Addendum # 6

PROJECT NAME: SUU Old Main Building Renovation
Southern Utah University
Cedar City, Utah

DATE: September 20, 2004

DFCM Project No.: 003234730
CRSA Project No.: B04-012

Add. 6.1

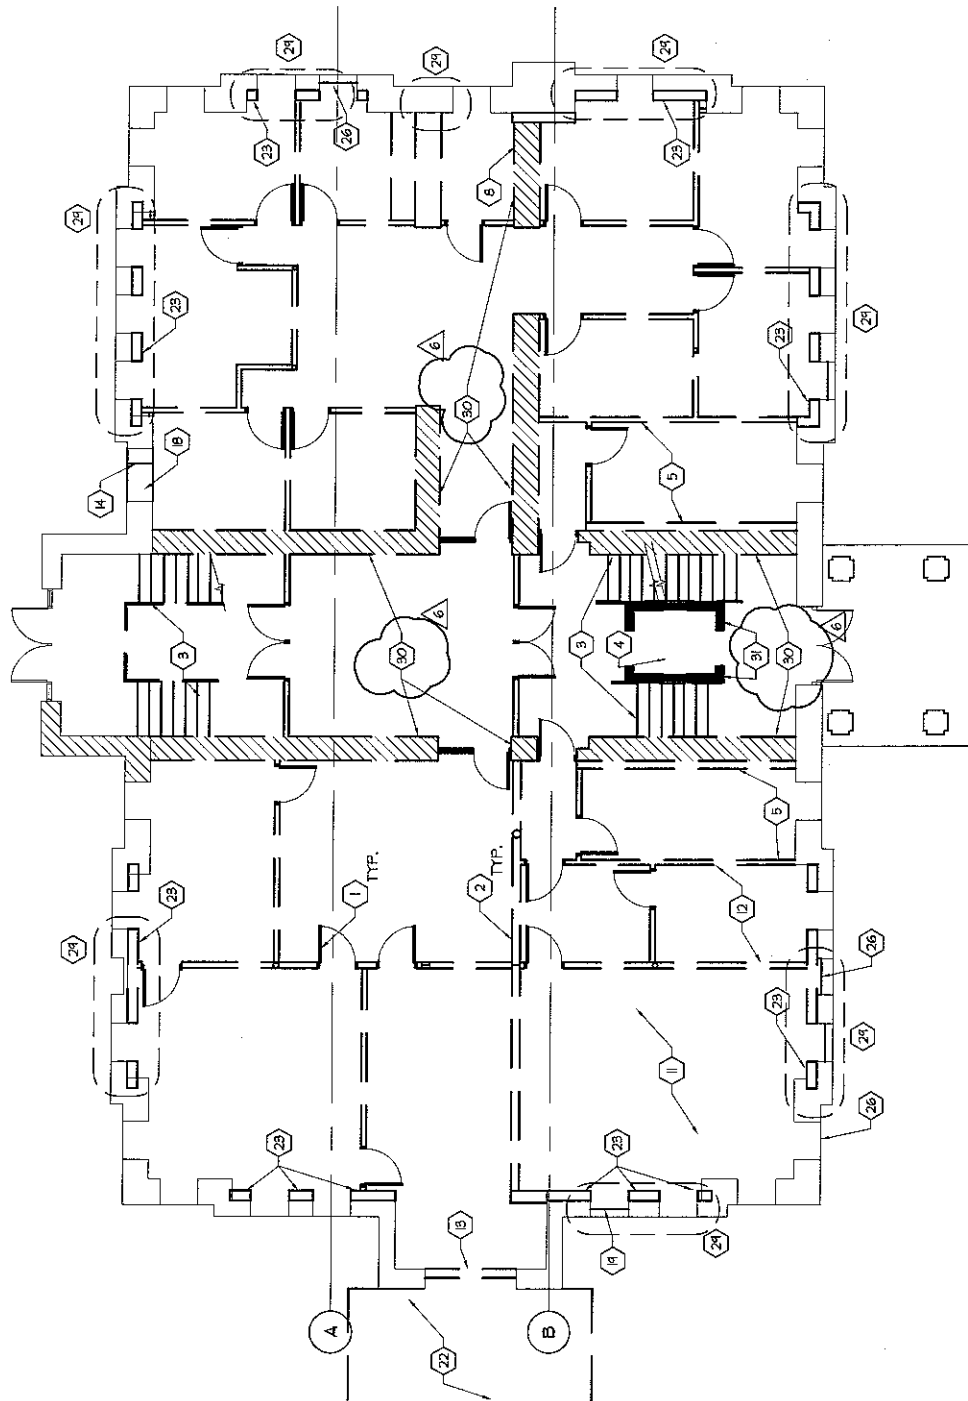
- VI-3 AD101 – Demolition Plan
- a) Clarification Notes – Notes 30 & 31 have been added to clarify known concrete and masonry walls. Again, existing 1940's and 1970's drawings are available to review. See attached drawings Add 6.1 – 6.4.
